# CITY OF ALBUQUERQUE

**RE: International Library Pond – Phase 1 & 2  
Drainage Report  
Engineer's Stamp Date: 08/04/23  
Hydrology File: K19D005A  
CPN: 722596**

Based upon the information provided in your submittal received 08/04/2023, the Drainage Report **is not** approved for Work Order. The following comments need to be addressed for approval of the above referenced project:

## International District Library Surge Pond Drainage Report

TITLE: INTERNATIONAL DISTRICT LIBRARY  
SURGE POND - PHASE 1  
GRADING PLAN

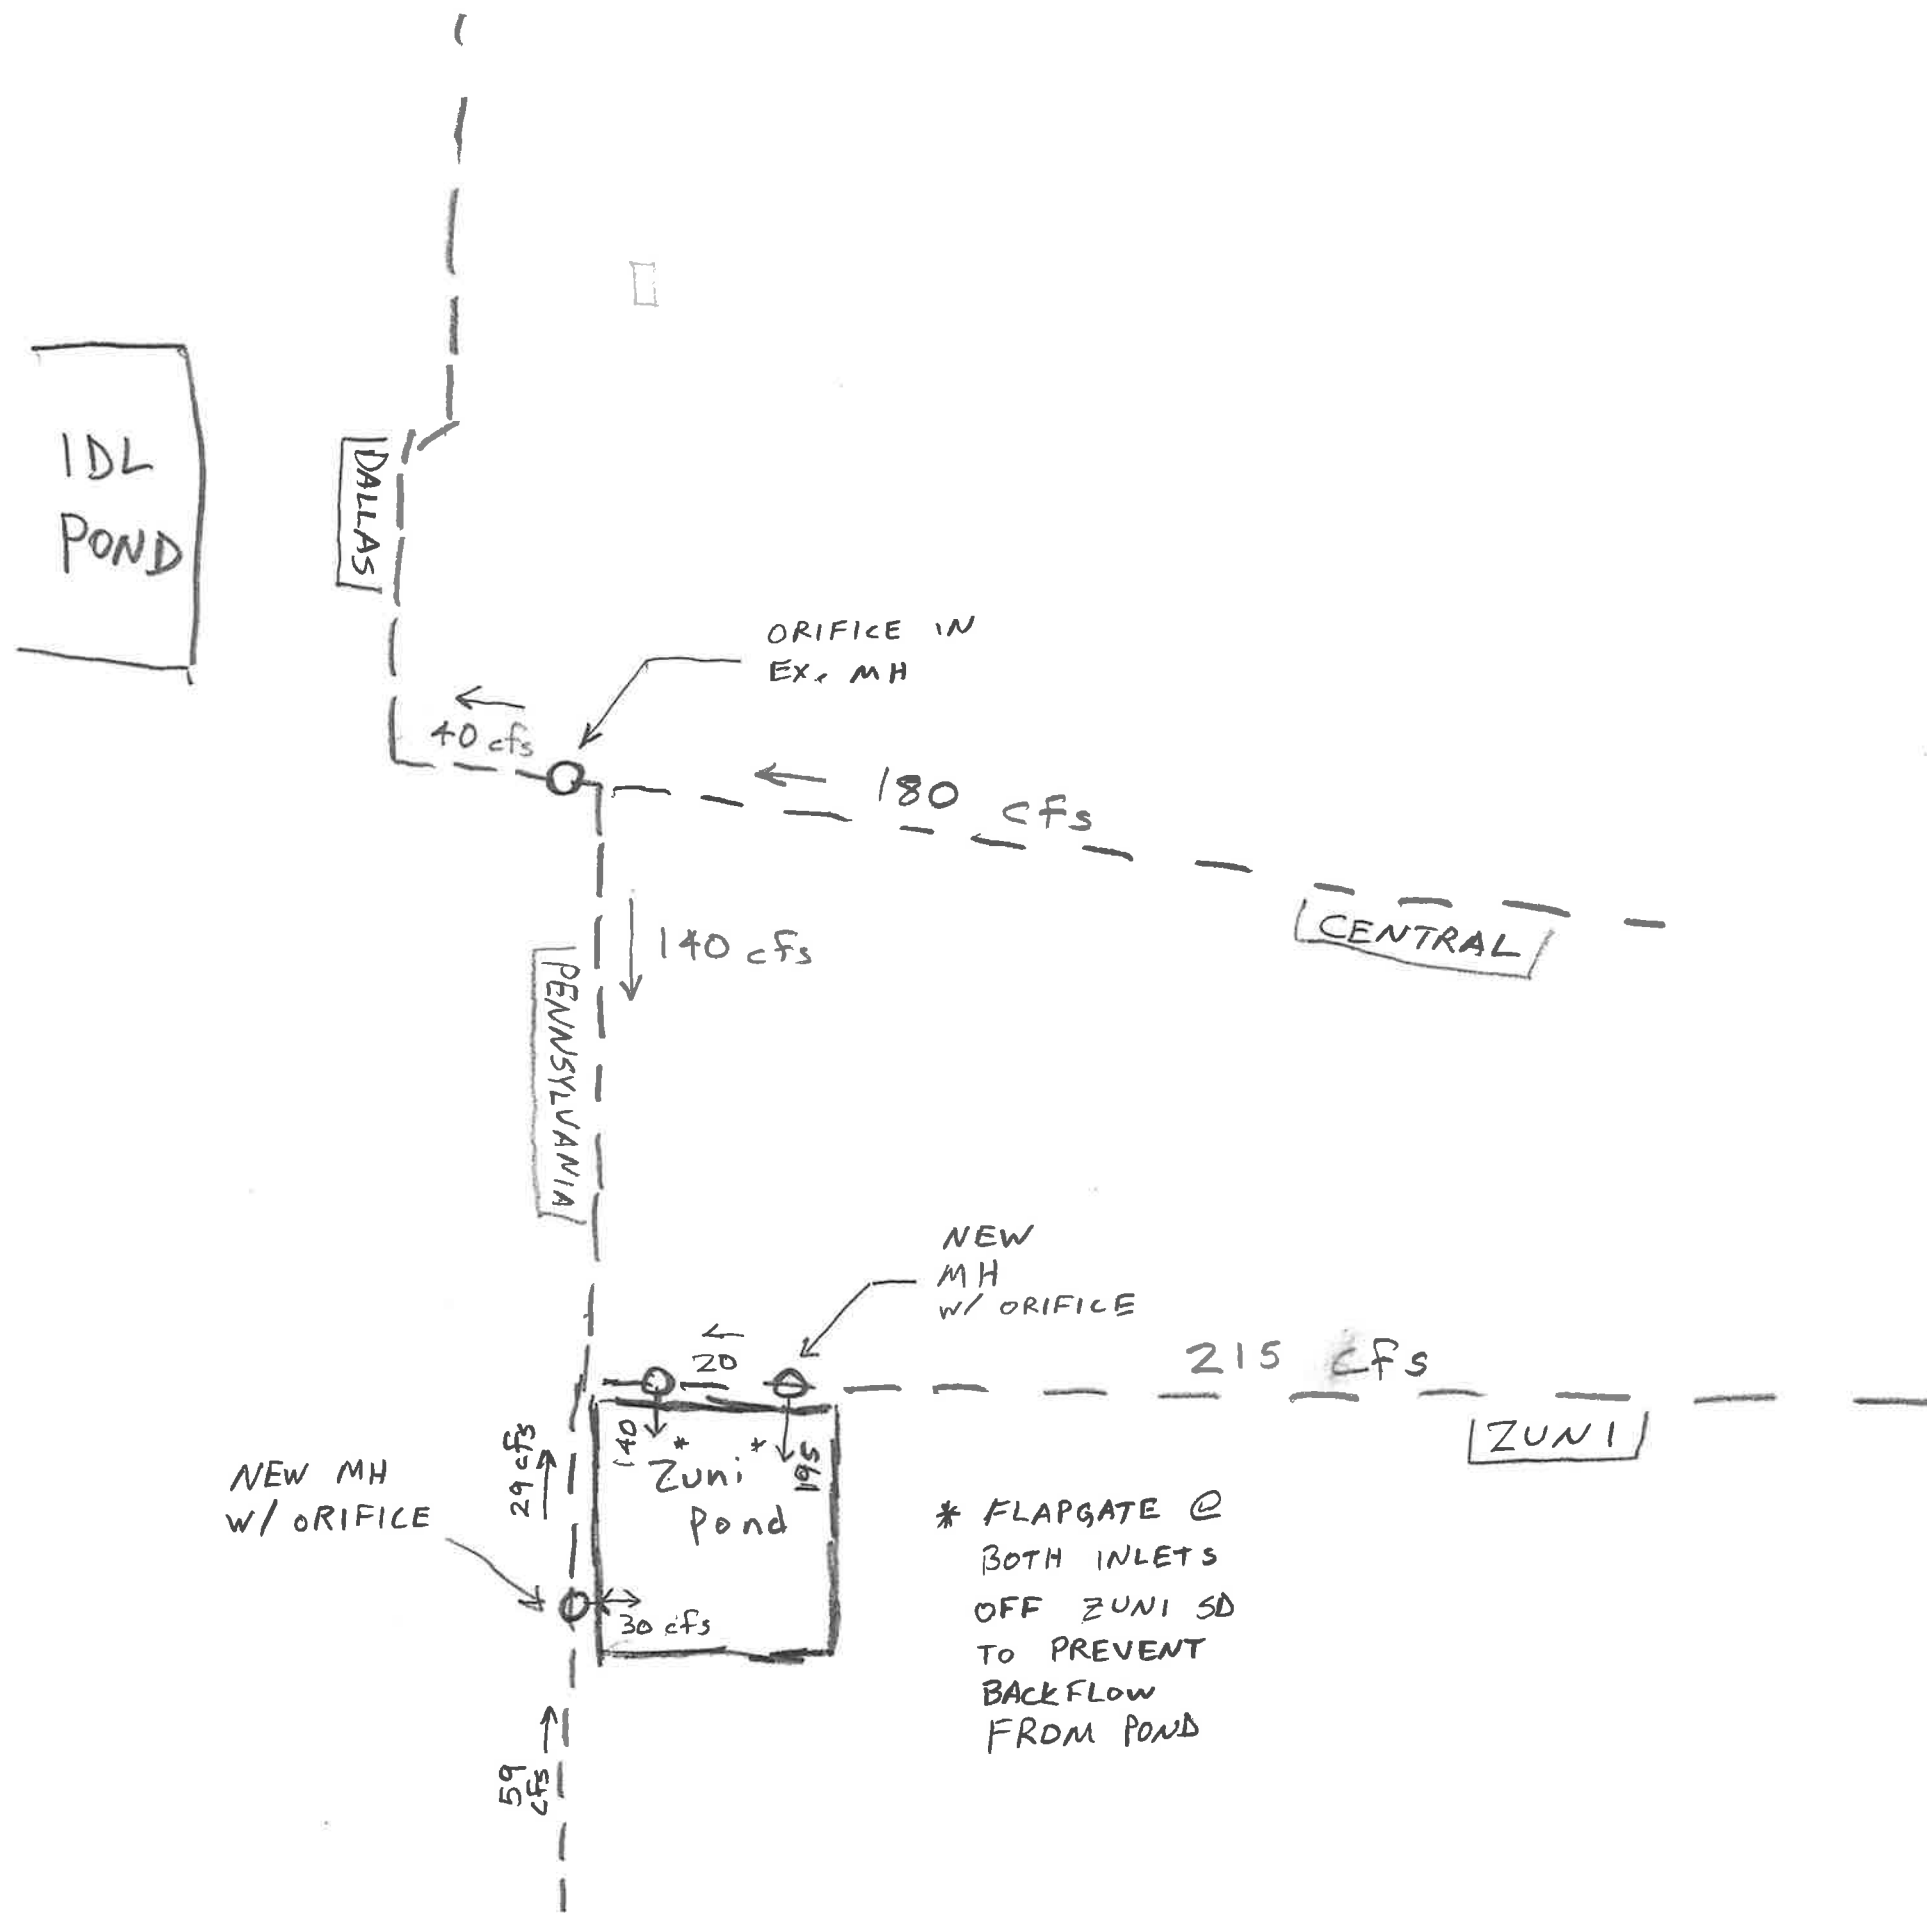
2. Hydrology has discussed what needs to be included in Phase 1 with Jim Roeder (DRC) and Jared Romero (AMAFCA) and the Drainage Report and Phase 1 Work Order (CPN 722596) will need to be revised to include installing the cattleguard inlet and connecting to the pond. With this in mind, the report needs to address the following items:

- a. Calculate the  $Q_{100}$  that is coming down Chico ( $Q_1$ ). This can be from a previous Master Drainage Plan.
  - b. Calculate the  $Q$  that will be collected by the new cattleguard inlet. ( $Q_2$ )

- c. Calculate the  $Q$  that bypasses the cattleguard inlet. ( $Q_3$ )
  - d. Calculate the volume that the pond will hold and use this to build an emergency spillway. This should be at the low spot along Chico.

- e. Calculate the  $Q$  that will then use the emergency spillway and enter Chico. ( $Q_4$ )

TITLE: INTERNATIONAL DISTRICT LIBRARY  
SURGE POND - PHASE 2  
STORM DRAIN PLAN AND PROFILE

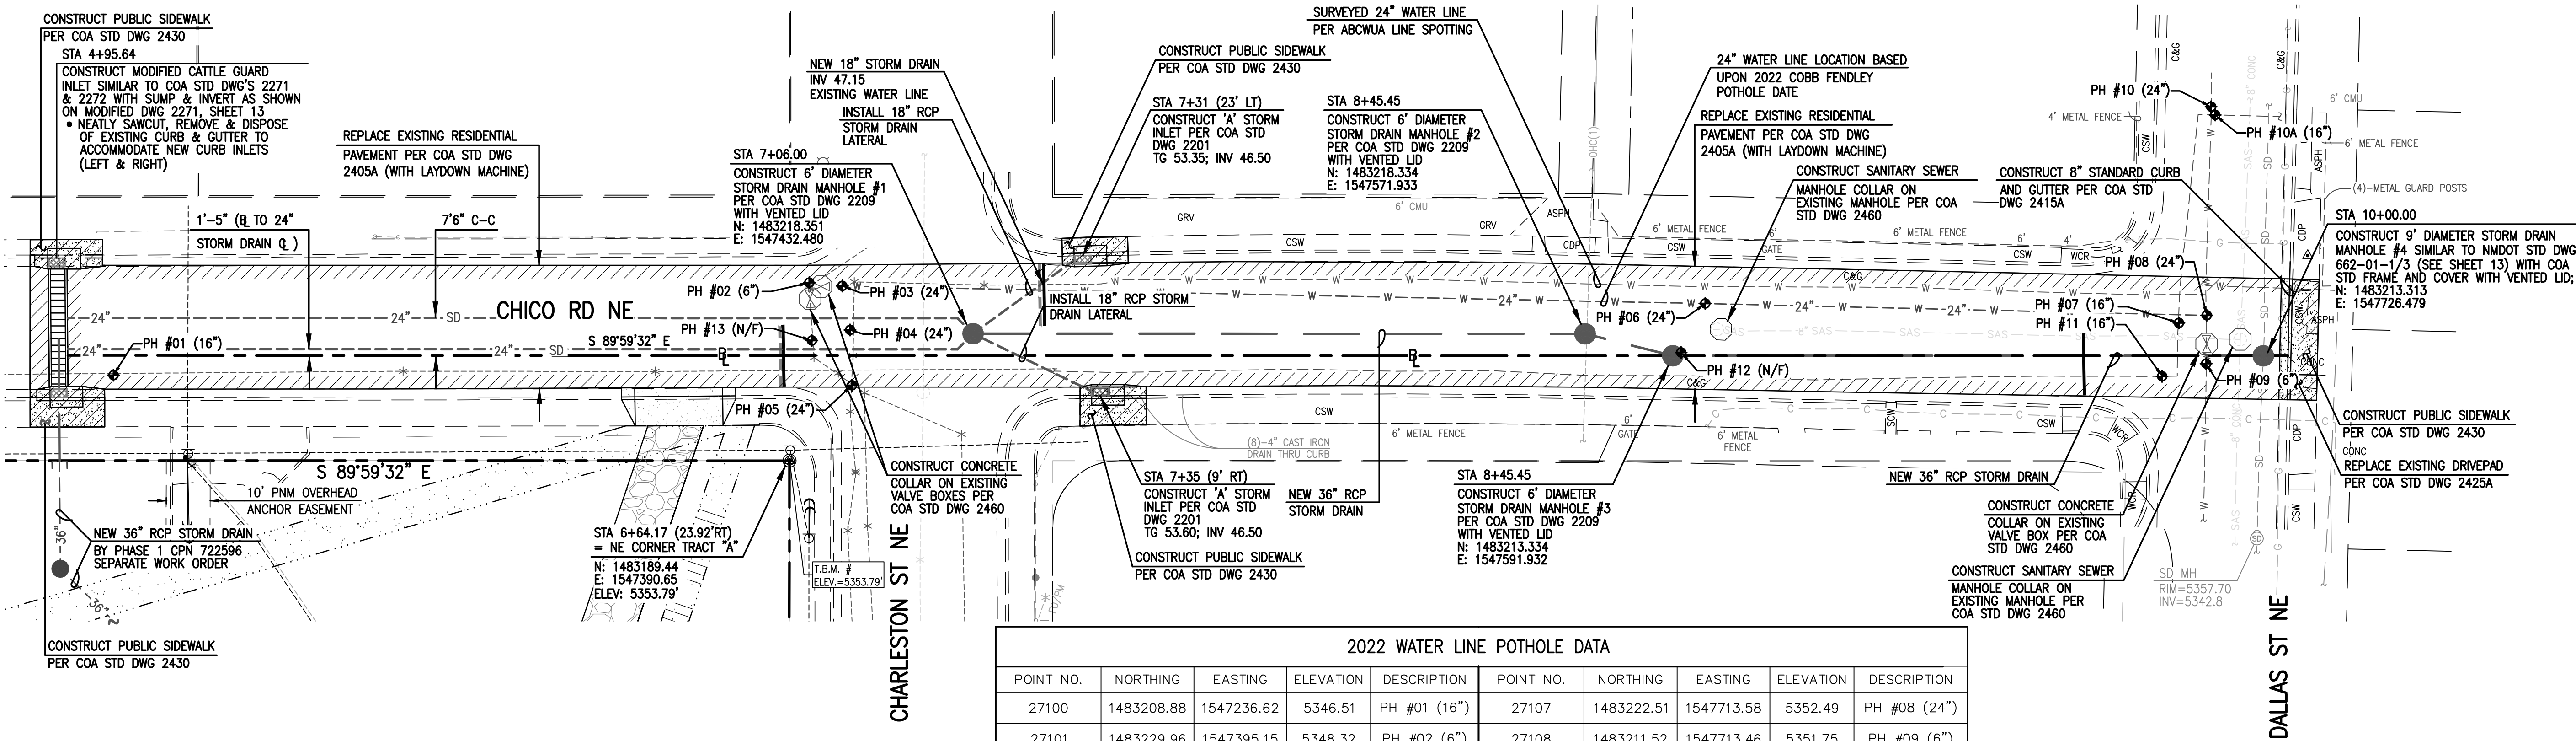
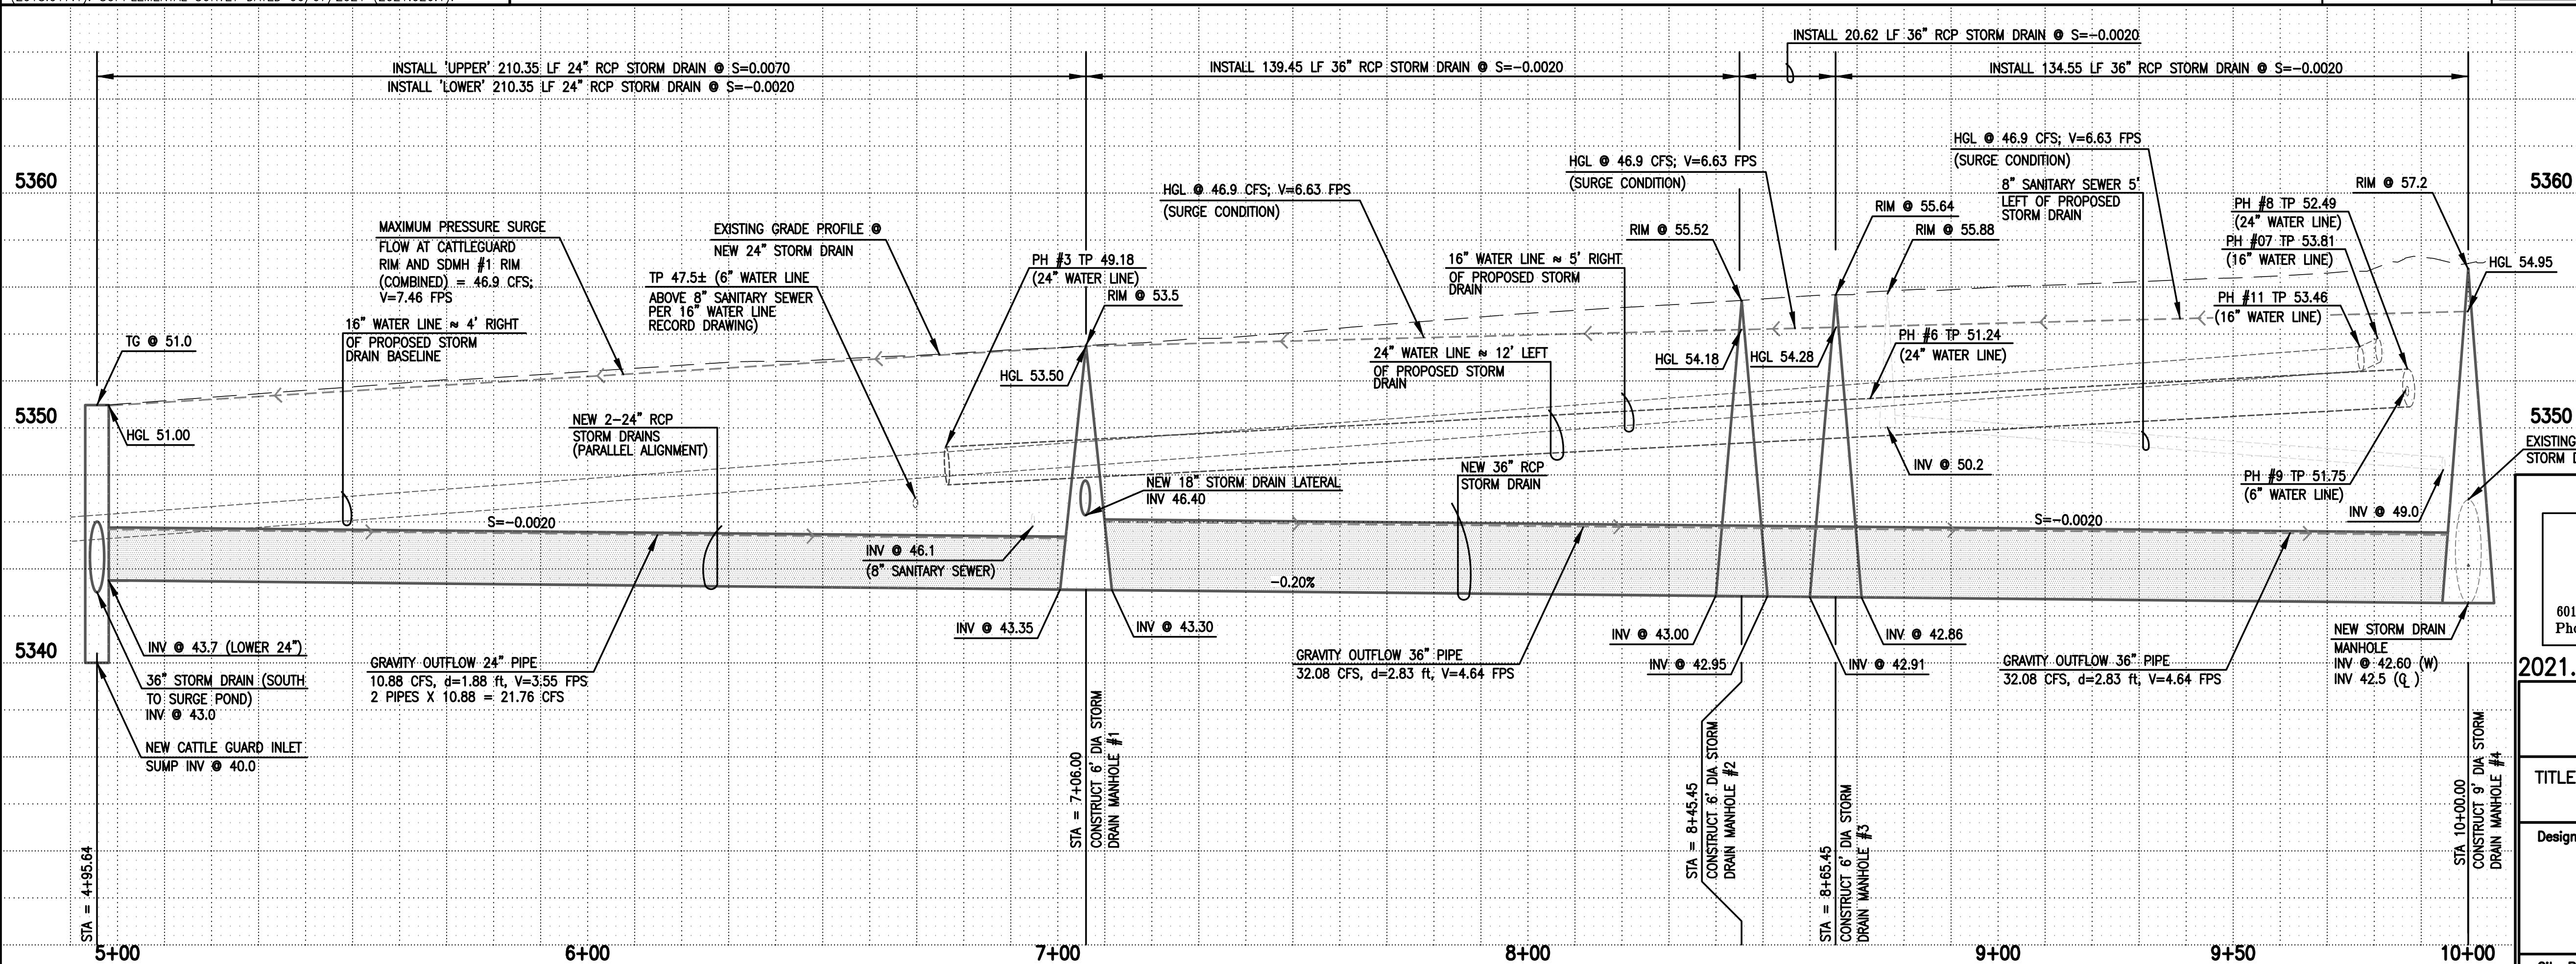
1. AMAFCA has reviewed the Drainage Report and discussed this project's Phase 2 (CPN 722597) and its coordination with the Zuni-Penn Pond Project and determined that the analysis shown for Phase 2 is not appropriate for the proposed drainage infrastructure. The hydraulic analysis provided does not adequately demonstrate anticipated facility performance of IDL as a surge pond for the Dallas Storm Drain. As such, AMAFCA will not approve or concur with any drainage report that does not analyze the storm drain system using EPA SWMM (or equivalent hydraulic modeling). AMAFCA is currently working with its engineering consultant for the design of the Zuni-Penn Pond to perform such analysis that includes the proposed Phase 1 and Phase 2 plans for the IDL pond.
